WARRANTY INFORMATION SERVICE INFORMATION Bulletin No. 2002-03
 PARTS INFORMATION

Motor Assembly Part Number Change

Models Affected

All 1990-1996 Hand and Foot Models

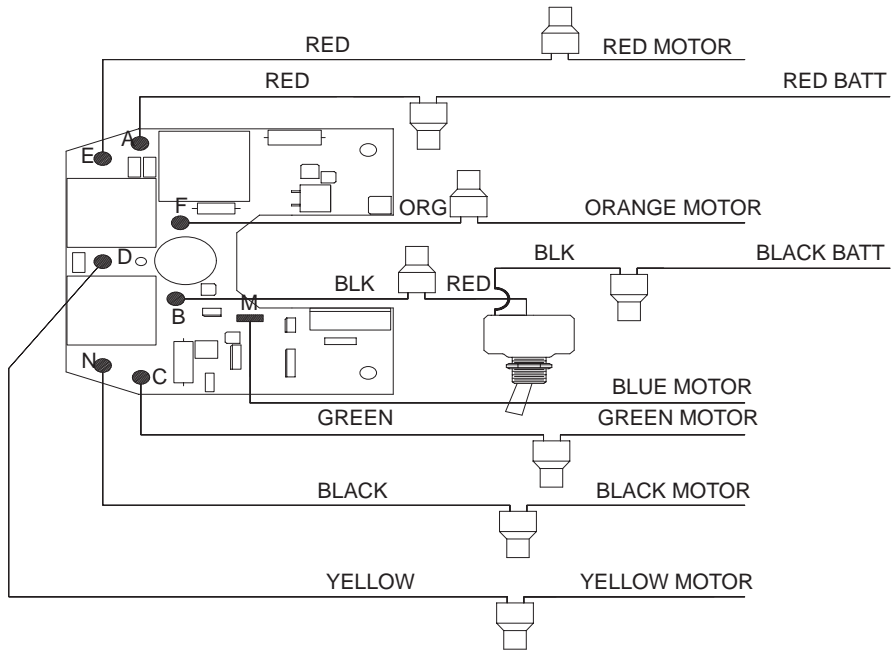
Hand Models: Motor assembly part number MCF397102 is No Longer Available (NLA). In order to replace the motor it is necessary to use motor assembly MCF397172. Use of this motor will also require installing a new board assembly (MAT15701) and a new handle assembly (MAT372052). Use the following wiring diagram to complete the installation of the new components.

Qty.1	MCF397172	Motor Assembly
Qty.1	MAT15701	Board Assembly
Qty.1	MAT372052	Handle Assembly

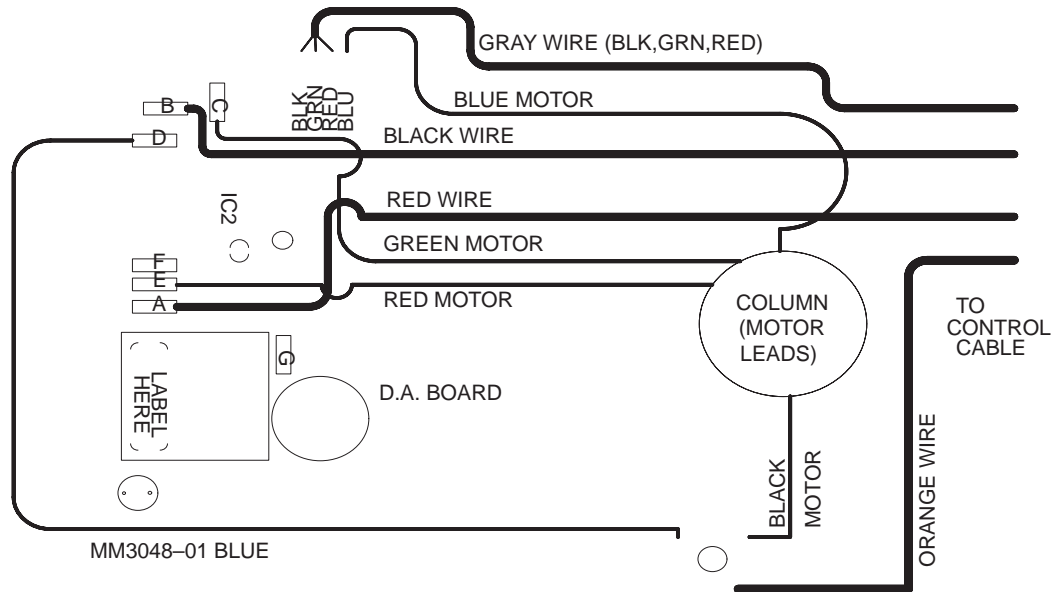
Foot Models: Motor assembly part number MCF397112 is No Longer Available (NLA). In order to replace the motor it is necessary to use motor assembly MCF397182. Use of this motor will also require installing a new board assembly (MAT15704). Use the following wiring diagram to complete the installation of the new components.

Qty.1	MCF397182	Motor Assembly
Qty.1	MAF15704	Board Assembly
